Hunterdon County Department of Health

Re: Septic System Waiver Request
Municipality: Clinton Township
Block: 4.03 Lot: 31
Location: 1070 Route 22

Re: Septic System Alteration Waiver
Municipality: Clinton Township
Block: 46.01 Lot: 3
Location: 5 John Dr.

Re: Septic System Waiver Request
Municipality: Clinton Township
Block: 43 Lot: 6
Location: 26 Hamilton Road

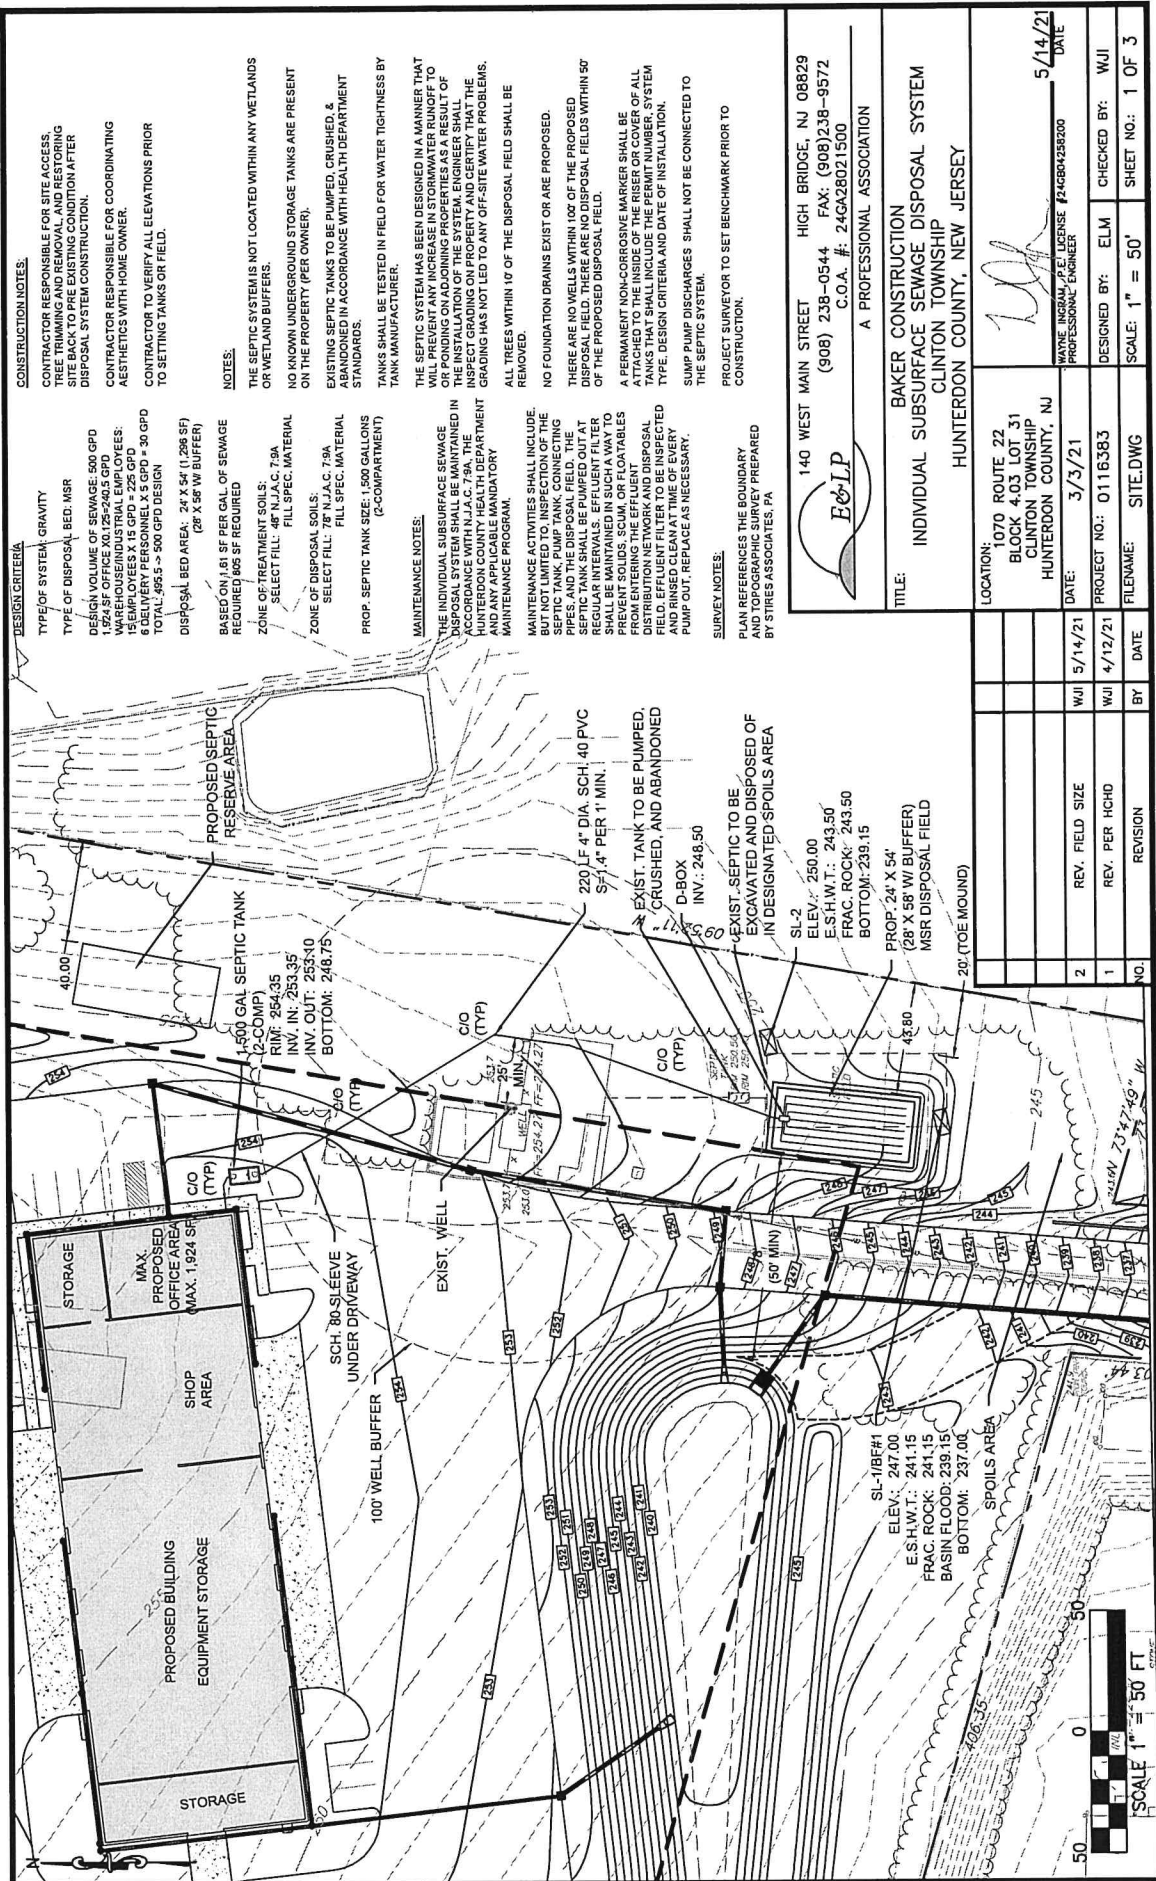
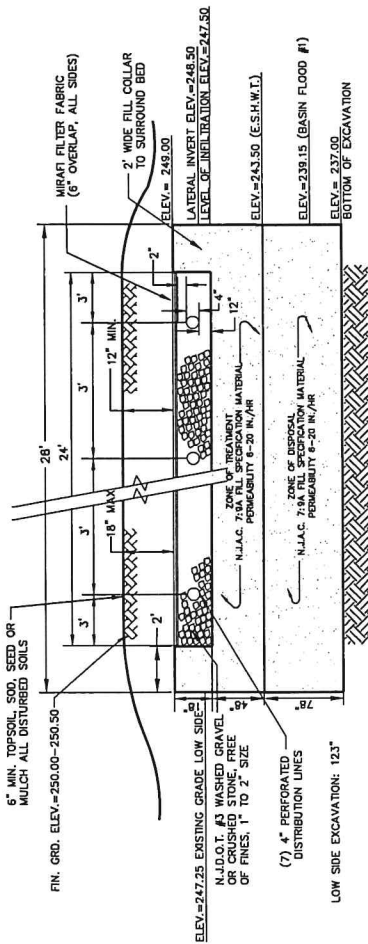
1. The proposed septic tank, disposal bed and the reserve area are all outside the building envelope.

The design engineer shall arrange to be at the next available Board meeting to present the design and waiver request to the Board.

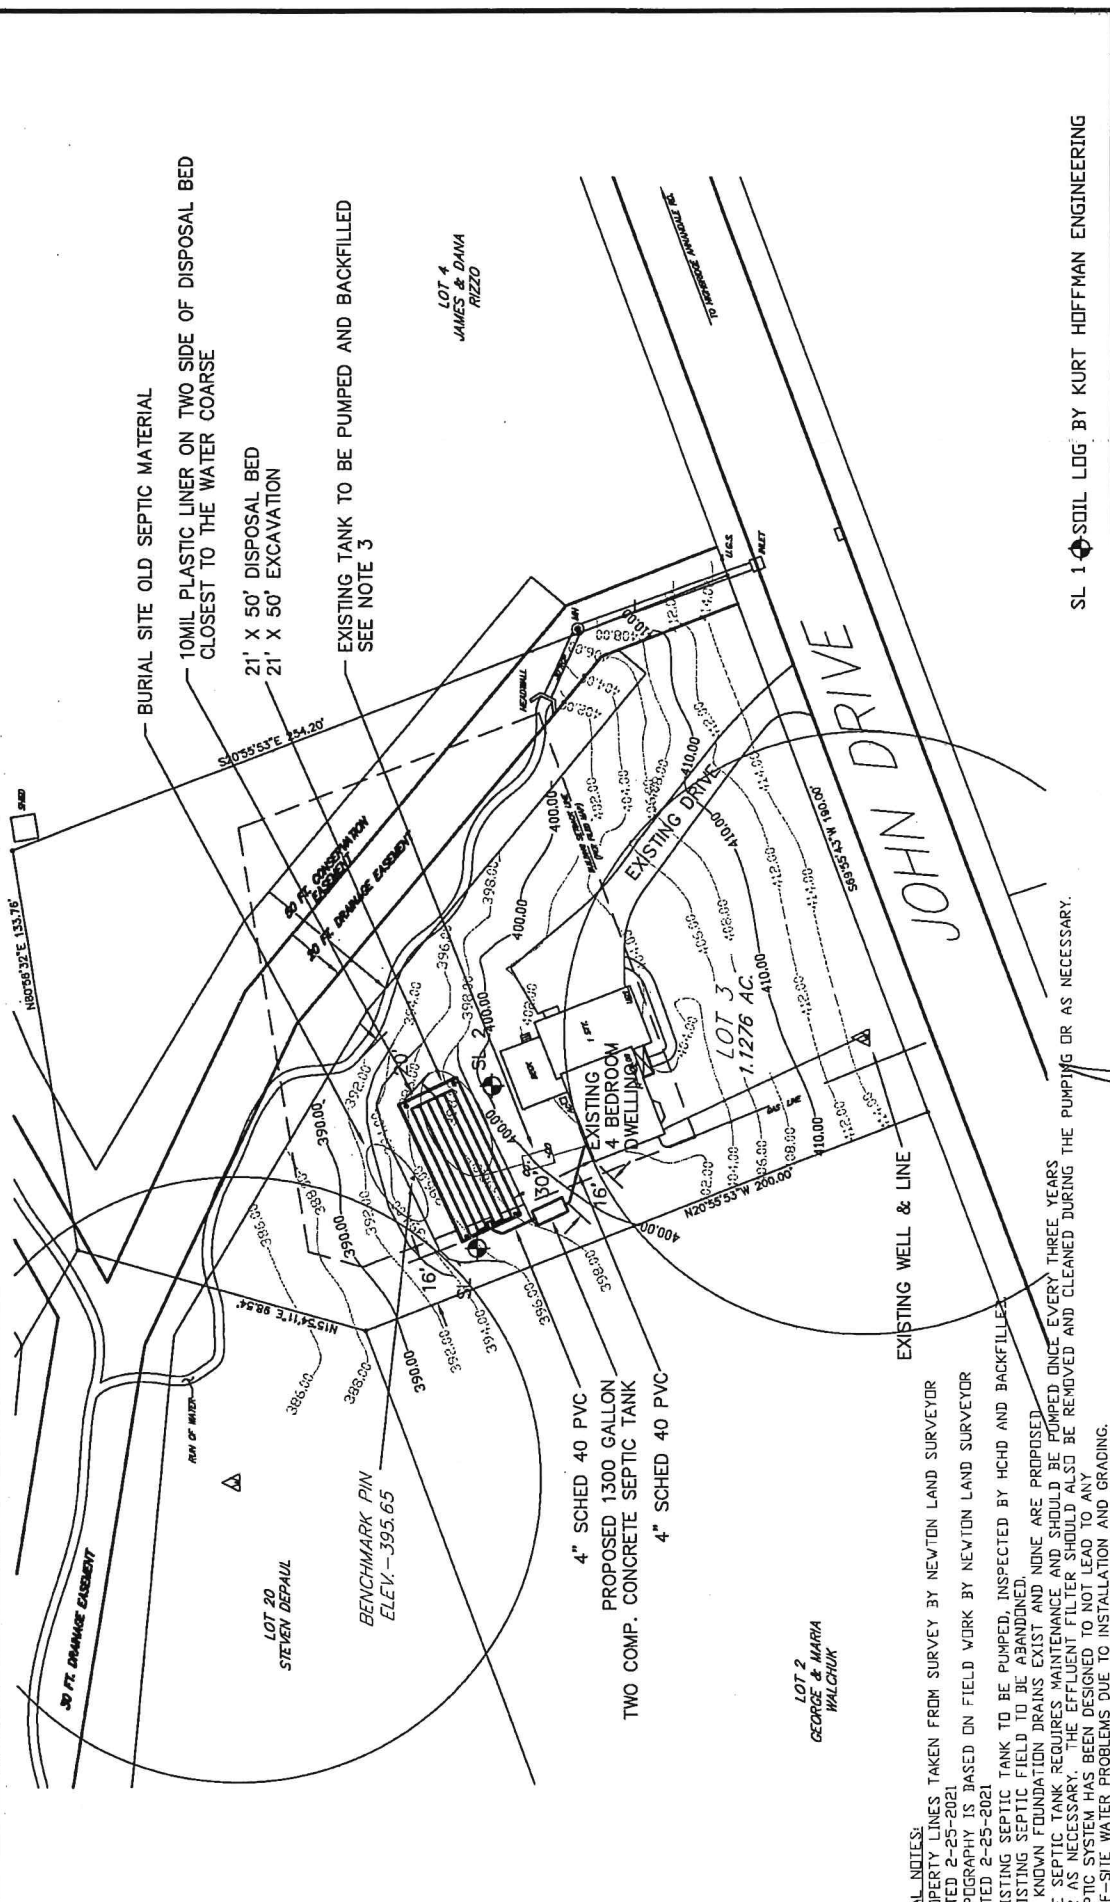
1. The proposed disposal bed will be only 20 feet from the existing water course which does not meet the minimum setback requirement of 50 feet according to state code. The engineer has proposed a 10 ml pvc liner on the two sides of the bed nearest the water course for further protection.

There are wetlands or transition areas near where the proposed disposal system will be located which will require a GP24 Permit from the DEP. The Board can conditionally approve the application with the applicant obtaining the Permit.

The engineer shall be at the next available Board meeting to present the waiver request to the Board.

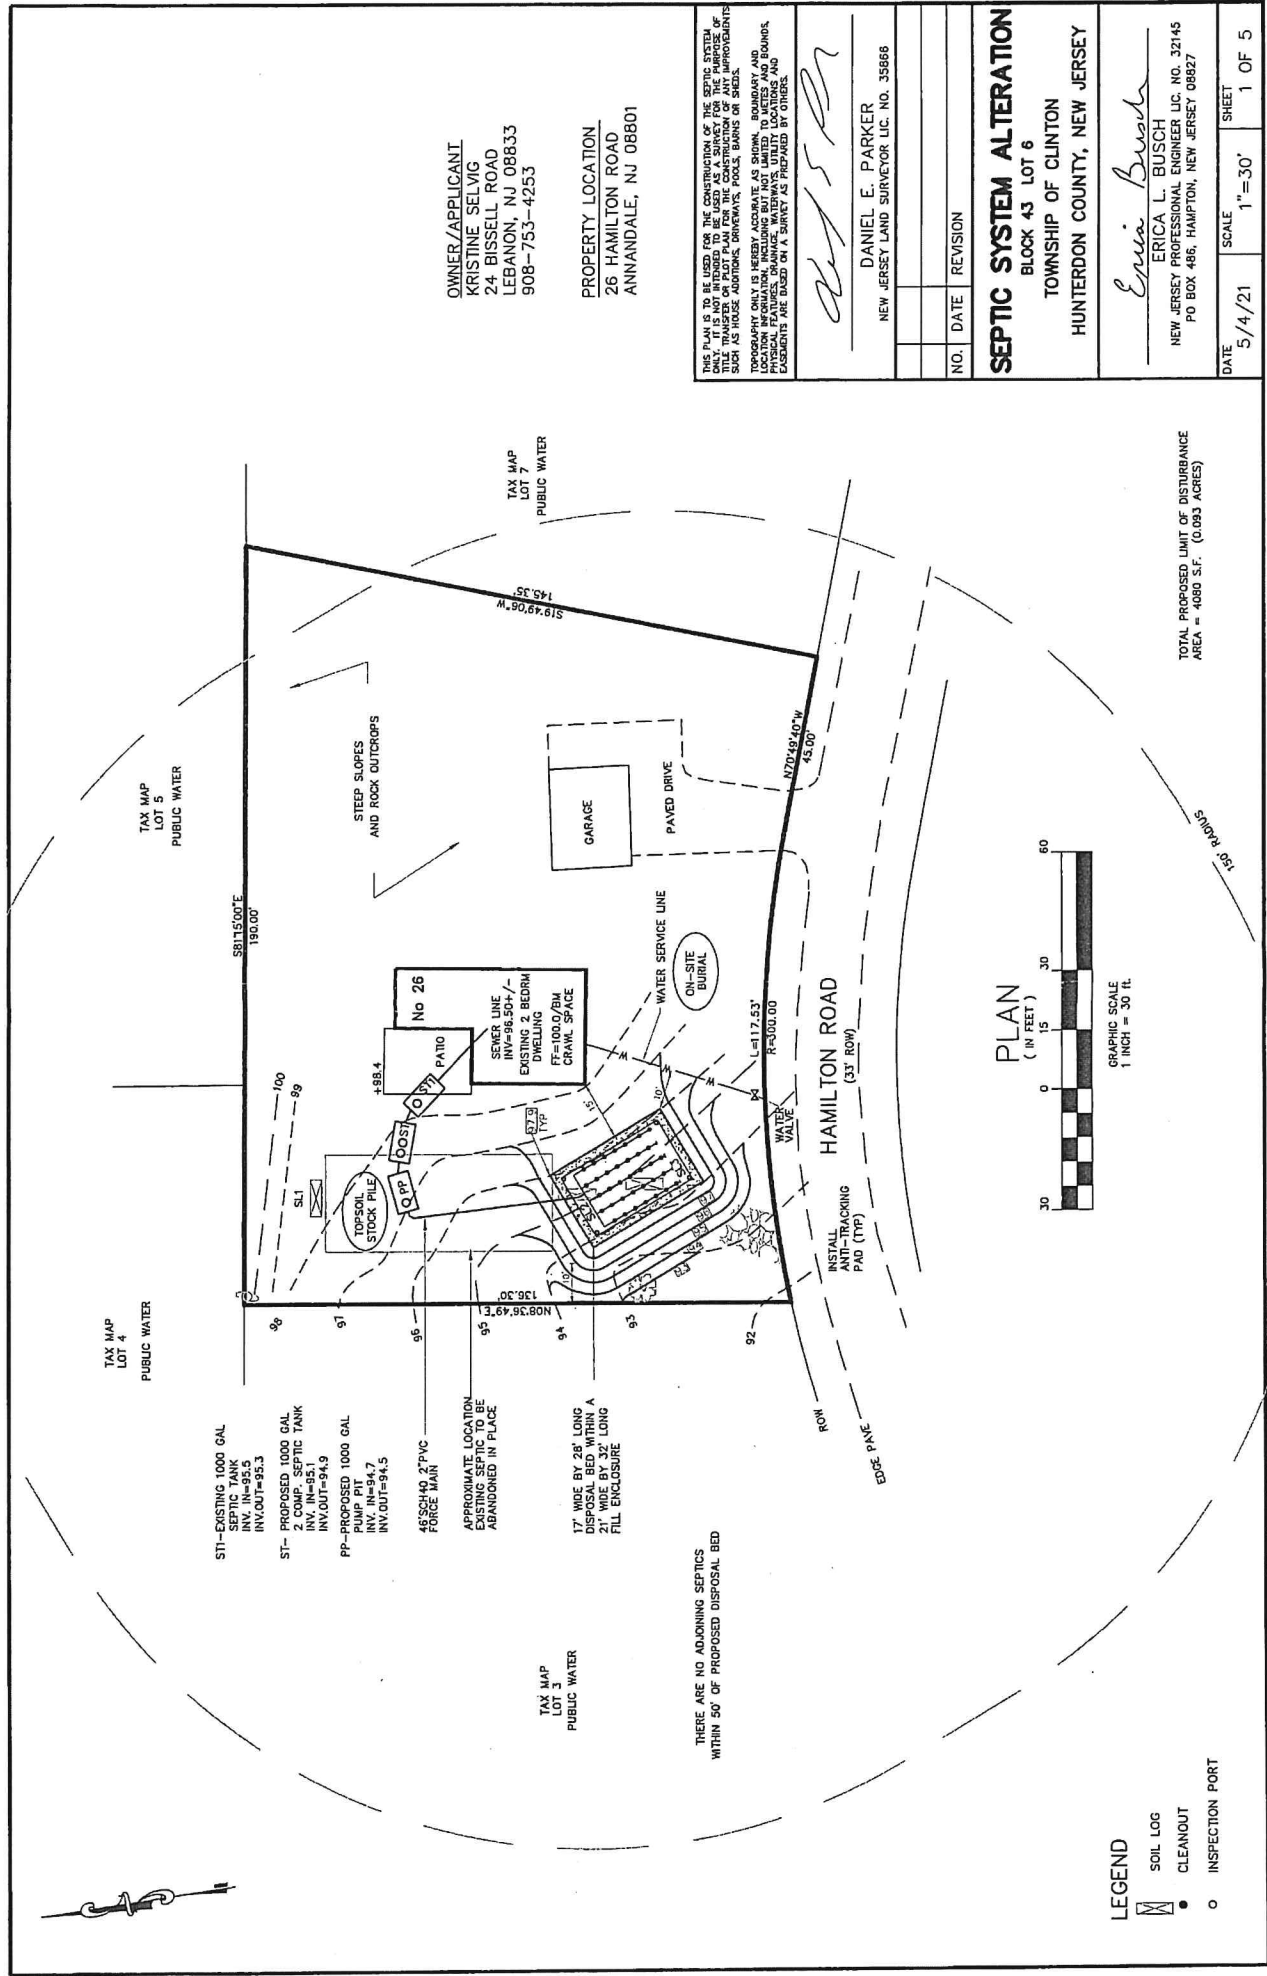
1. The toe of the mound will be less than the required 10 feet to the property line. The engineer shall inspect the final grading and provide certification that the grading does not adversely impact off-site conditions.
